**North Rockland High School Projects – Phase 2**

**MSA File No. 43045**

**NOTICE TO BIDDERS**

Re: **ADDENDUM NO. 1**

© COPYRIGHT, MICHAEL SHILALE ARCHITECTS  
 Drawing Title  
**ELECTRICAL PRESS  
 BOX PLANS**  
 Drawing No.  
**CE-106**

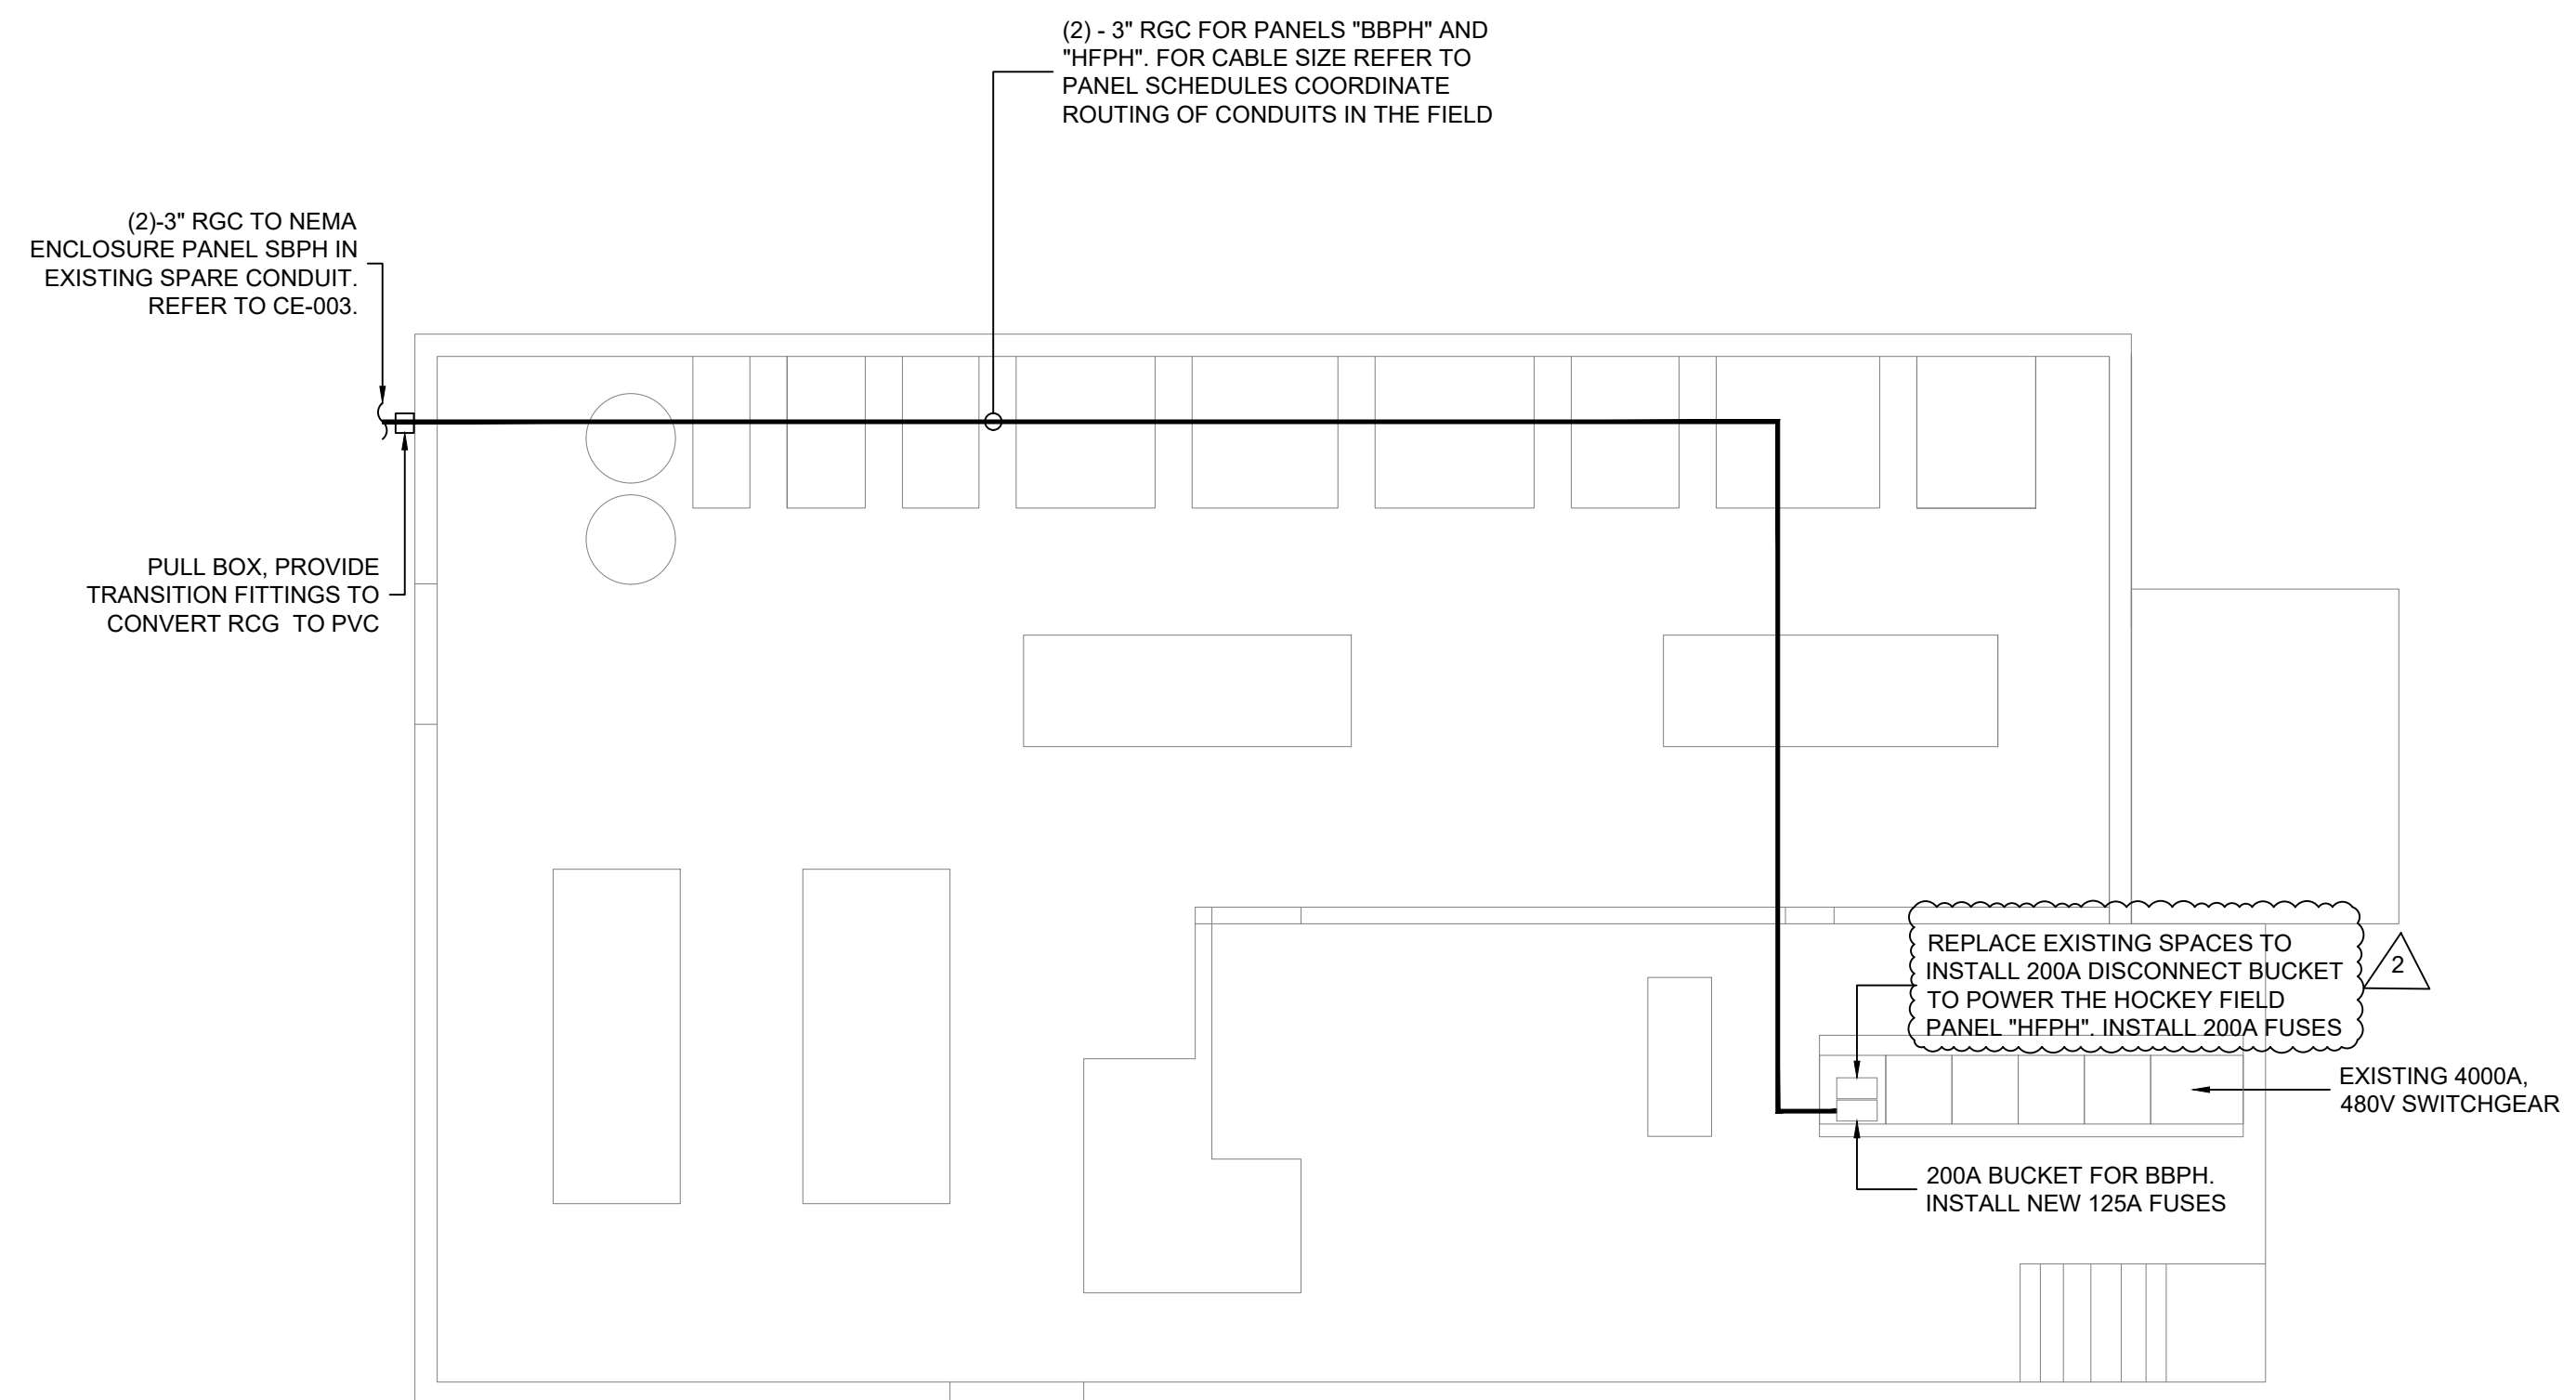
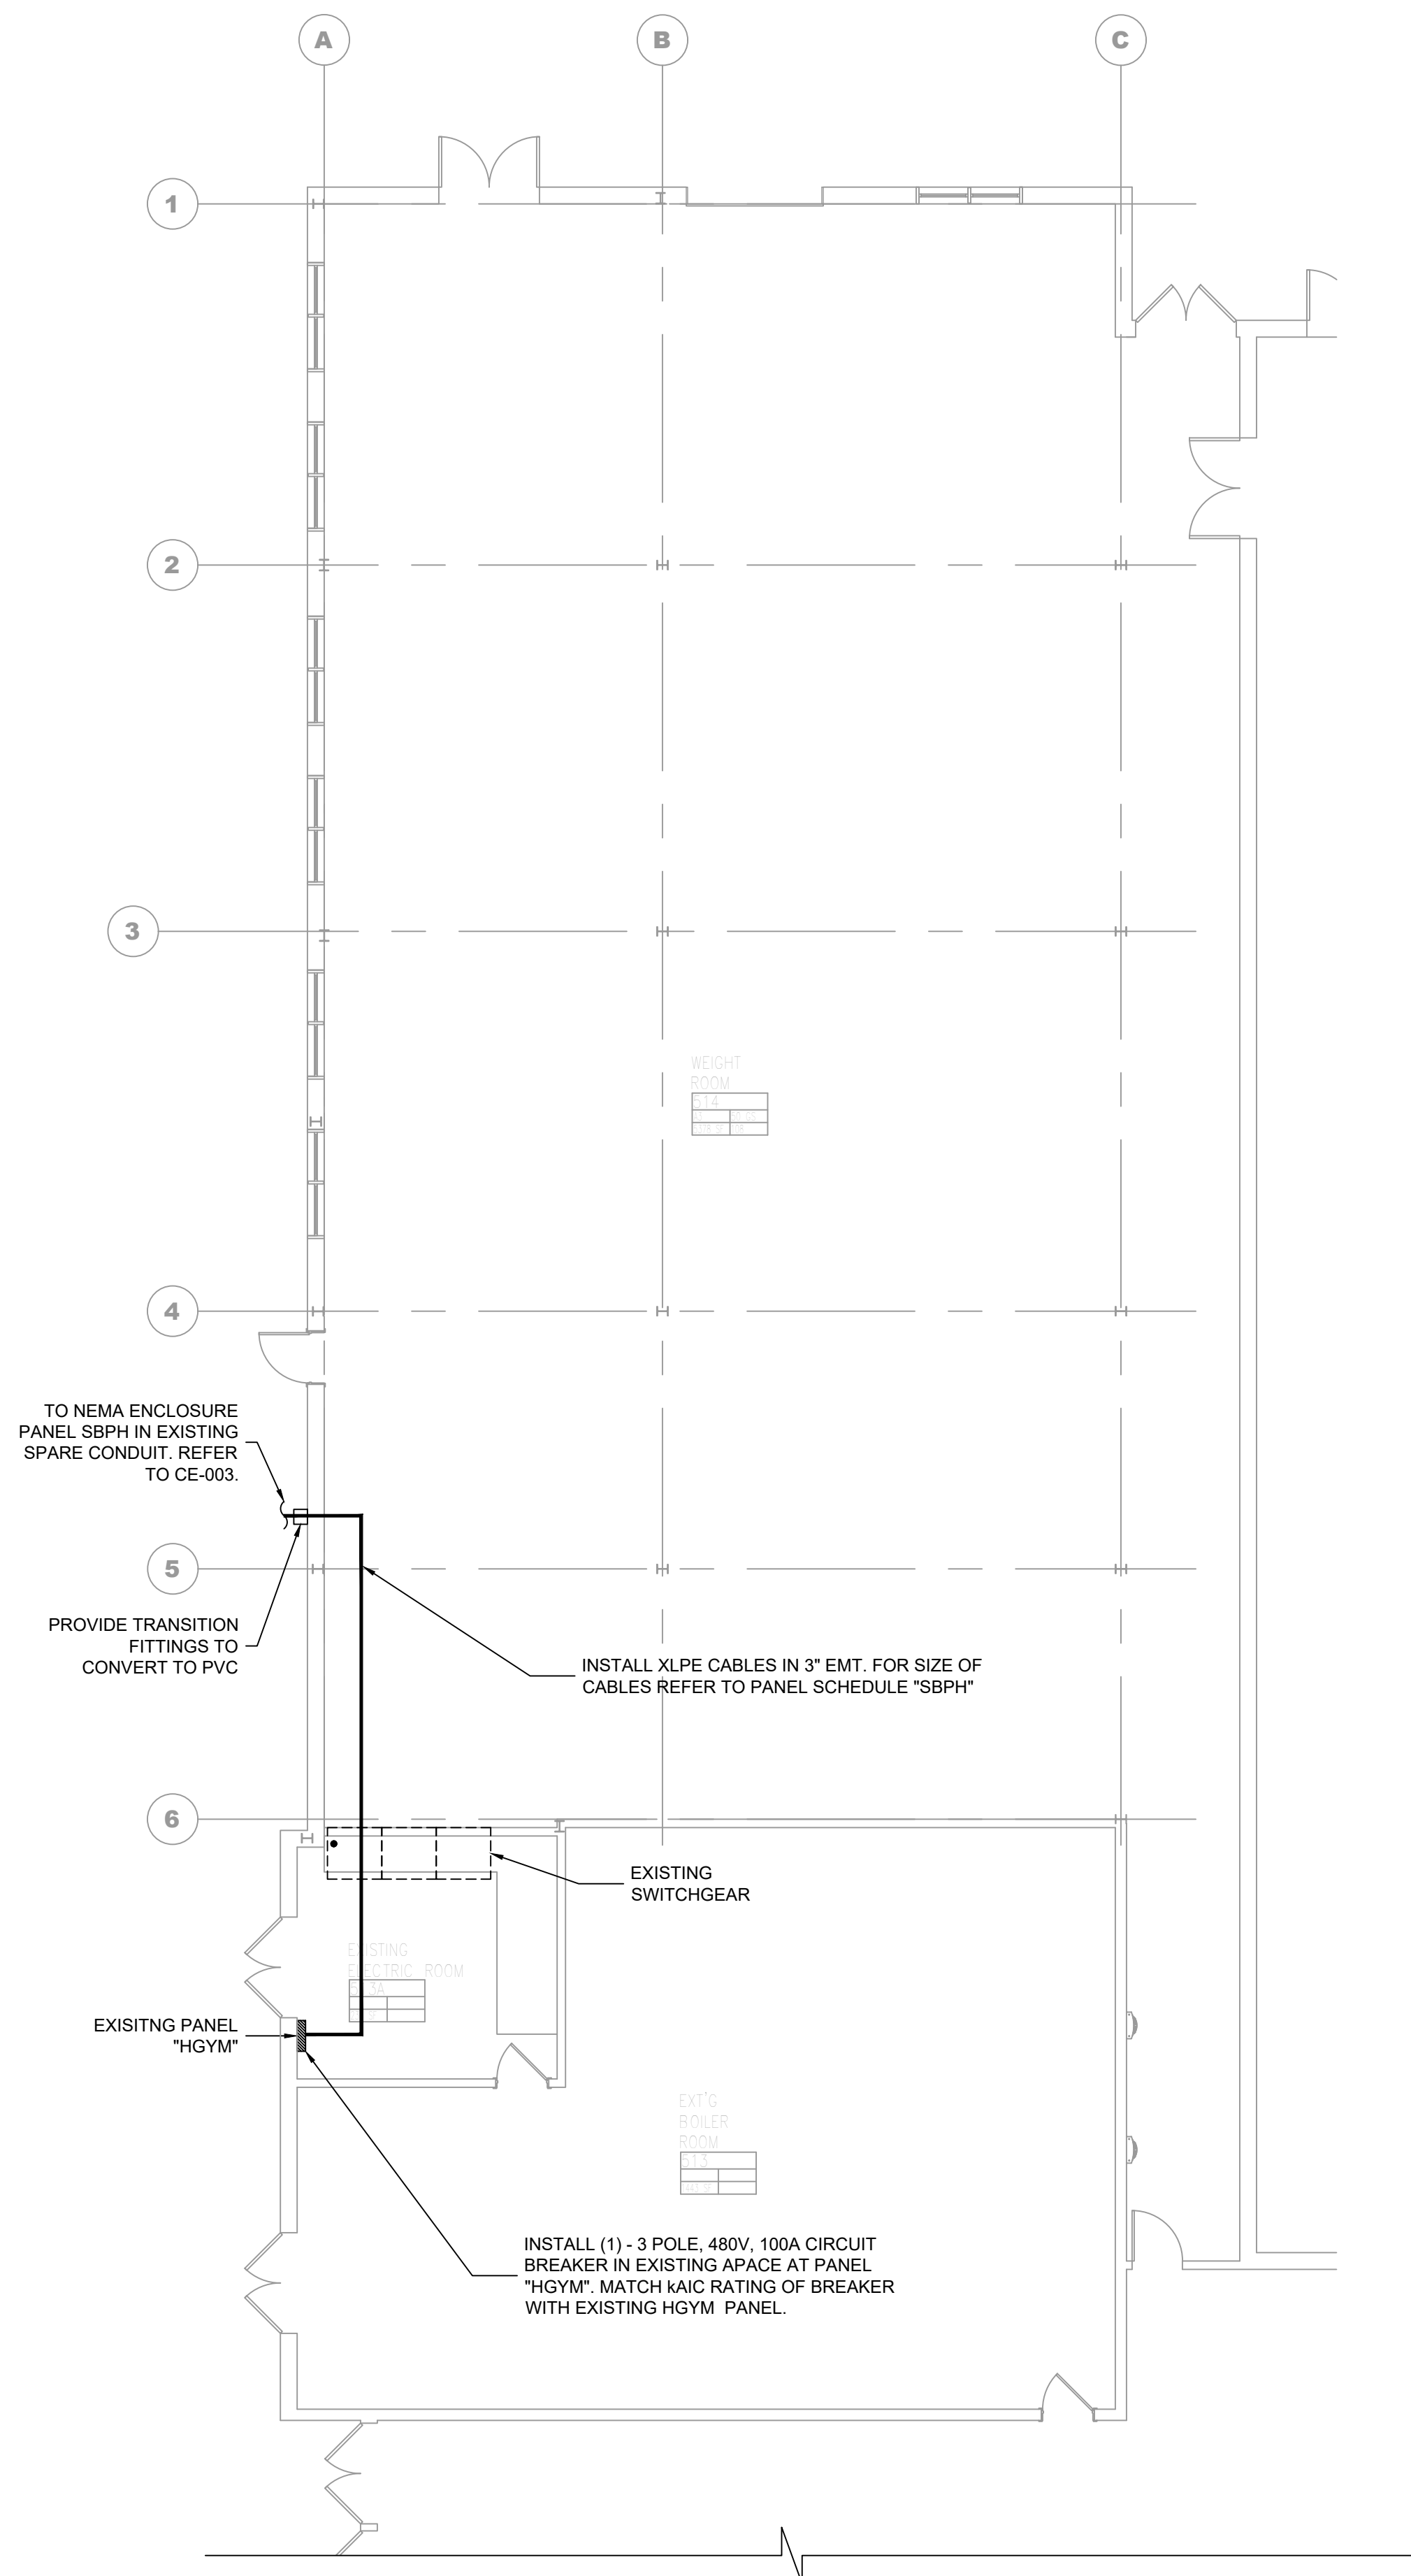
14) See attached revised drawing M-102, M-103 and CE-106. Plans and elevations of Press Boxes have been revised to match as shown in Architectural Drawings.
